UNITED STATES PATENT AND TRADEMARK OFFICE

APPLICATION NO.	FILING DATE	FIRST NAMED INVENTOR	ATTORNEY DOCKET NO.	CONFIRMATION NO.
09/855,026	05/15/2001	Evangelos Tirfon Laskaris	839-1008	7982

Office Action Summary	Application No.	Applicant(s)	
	09/855,026	LASKARIS ET AL.	
	Examiner	Art Unit	
	Guillermo Perez	2834

DETAILED ACTION

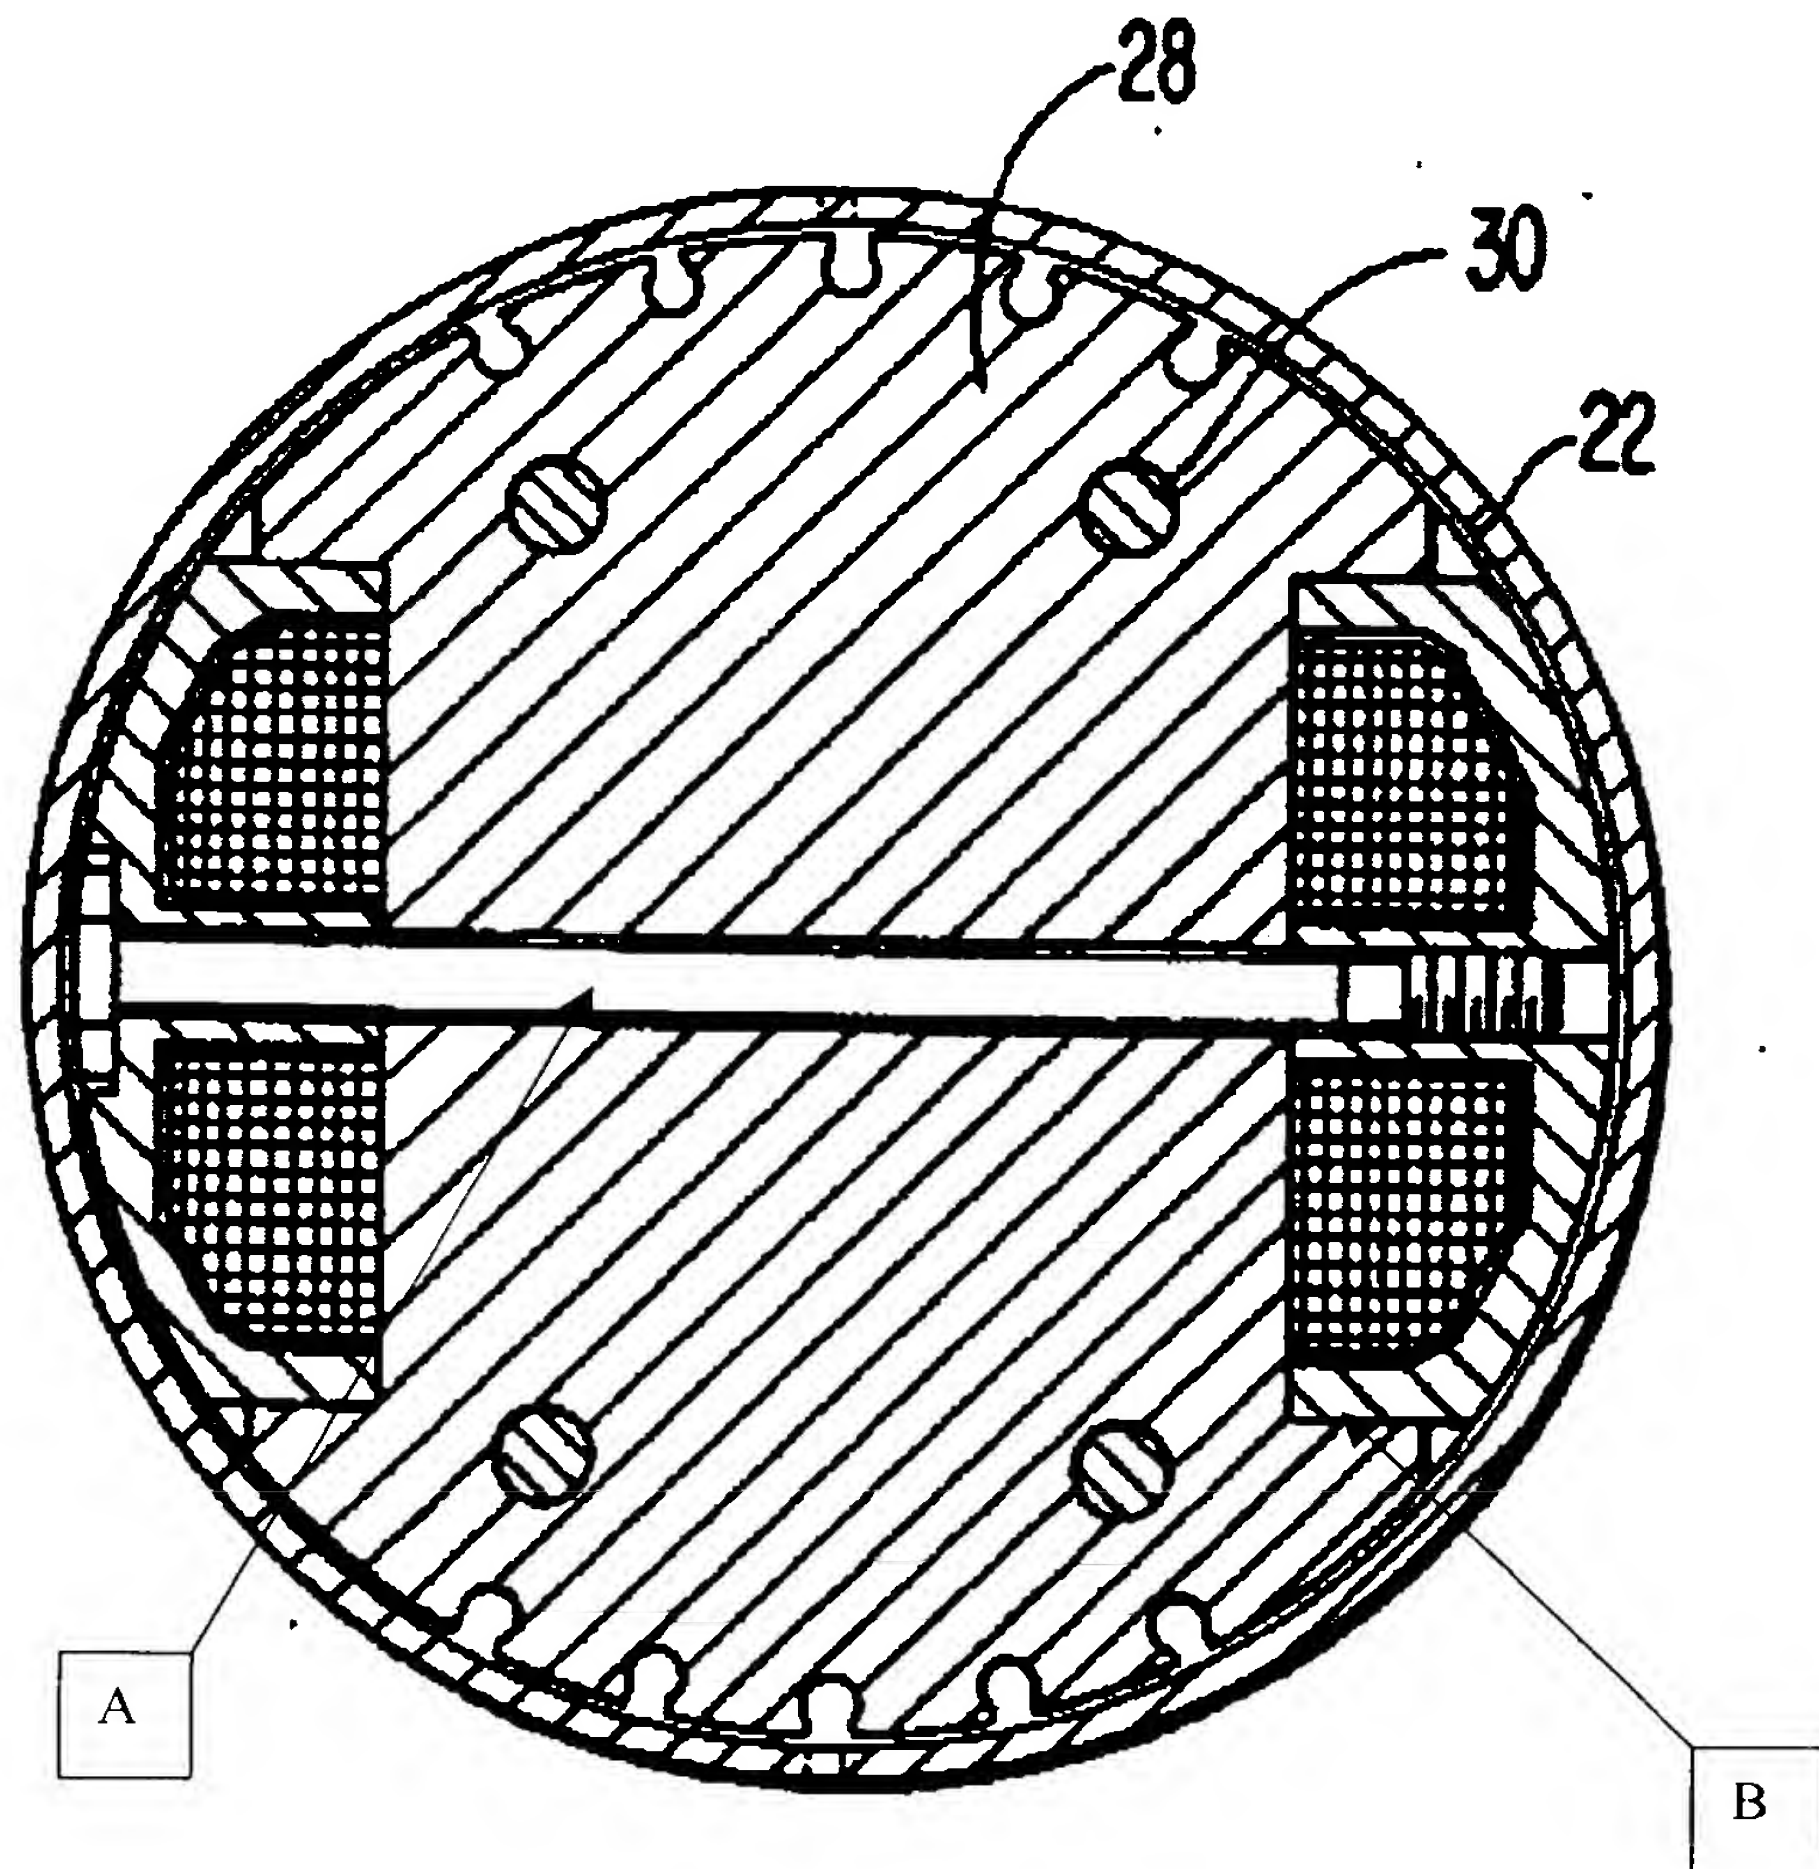
Shervington et al. disclose a rotor (figure 4) comprising:

at least one tension rod (A in figure attached) extending between the pair of side sections of the coil winding and through the rotor (28), in which

a coil housing (B) at each of opposite ends of the tension rod (A), in which the housing (B)

Shervington et al. disclose that the coil housing (B) is a U-shaped channel.

Shervington et al. disclose that the tension rod (A) extends through a longitudinal axis of the rotor (28). Shervington et al. disclose that the tension rod (A) extends through conduits in the rotor core (28). Shervington et al. disclose that the tension rod (A) is
